FORM APPROVED  
OMB NO. 1004-0135  
Expires: July 31, 2010**SUNDRY NOTICES AND REPORTS ON WELLS**  
*Do not use this form for proposals to drill or to re-enter an abandoned well. Use form 3160-3 (APD) for such proposals.*5. Lease Serial No.  
NMLC029419A

7. If Unit or CA/Agreement, Name and/or No.  
SKELLY UNIT8. Well Name and No.  
SKELLY UNIT 549. API Well No.  
30-015-0535110. Field and Pool, or Exploratory  
GRAYBURG JACKSON11. County or Parish, and State  
EDDY COUNTY, NM**SUBMIT IN TRIPLICATE - Other instructions on reverse side.**

**Skelly Unit 54  
Forest Oil Corporation  
December 5, 2007  
Plug and Abandonment Procedure  
Conditions of Approval**

**Proposed Wellbore Diagram**

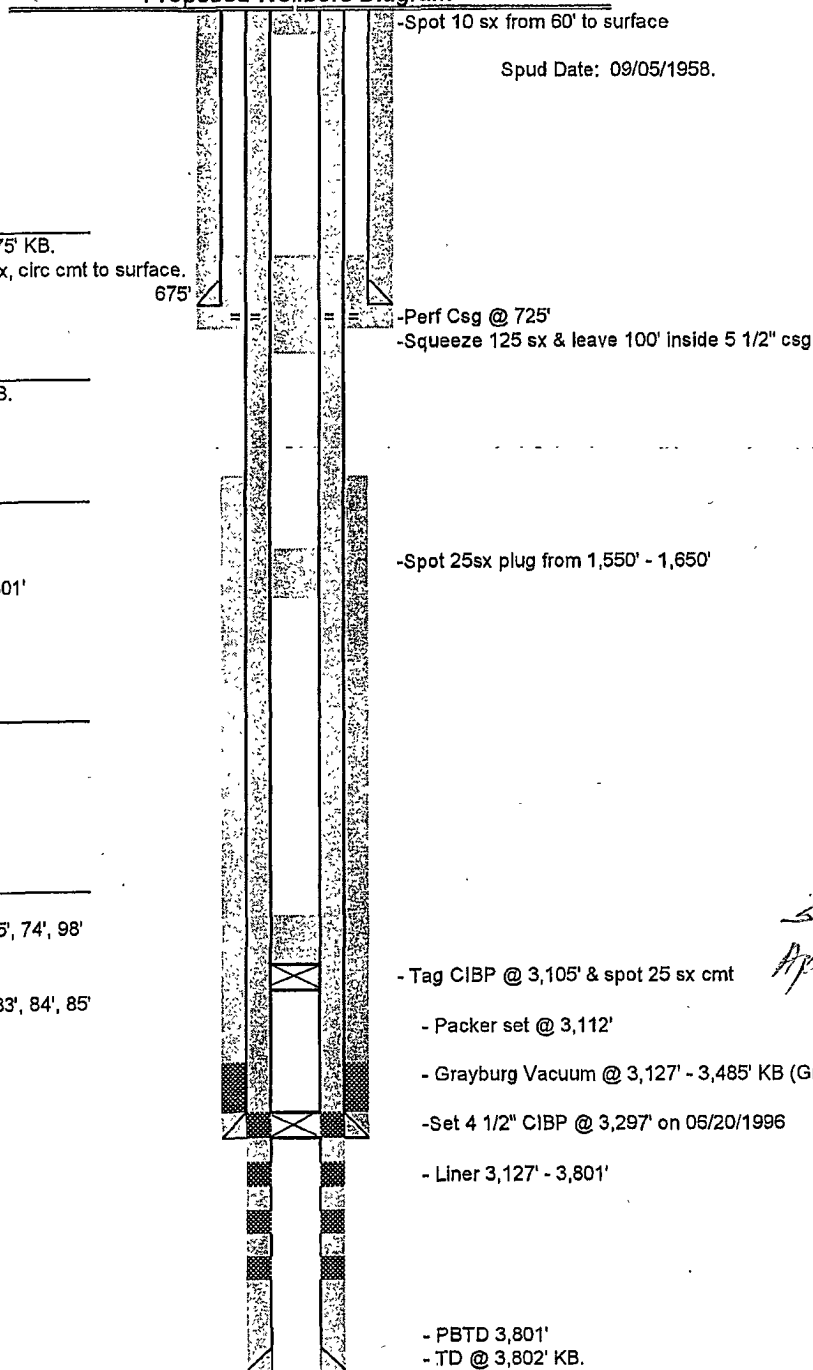
- 1. CIBP set at 3105' was set without BLM approval. CIBP at 3297' should have had cement placed on top of it. Reminder – an injection well that penetrates federal minerals must have all proposed work approved by the BLM.**

- 2. No records found on surface casing, but calculation indicates 100% excess. When wellhead is removed, verify that cement is at surface.**
- 3. Tag CIBP at 3105' and spot 25 sacks of cement.**

- 4. Circulate hole with mud laden fluid – minimum 9 ppg (see COA).**
- 5. Perforate at 1600' and attempt to squeeze a minimum of 25 sacks. If not possible to squeeze, set 25 sack plug in the casing. Plug to be tagged at 1490' or shallower. Base of Salt.**

- 6. Perforate at 725'. Attempt to establish circulation to surface. If possible, pump cement to surface. Otherwise pump proposed 125 sacks. WOC 4 hours and tag plug at 530' or shallower. Top of Salt.**

- 7. If cement not circulated to surface, casing to be perforated at 60', cement circulated to surface and casing filled.**
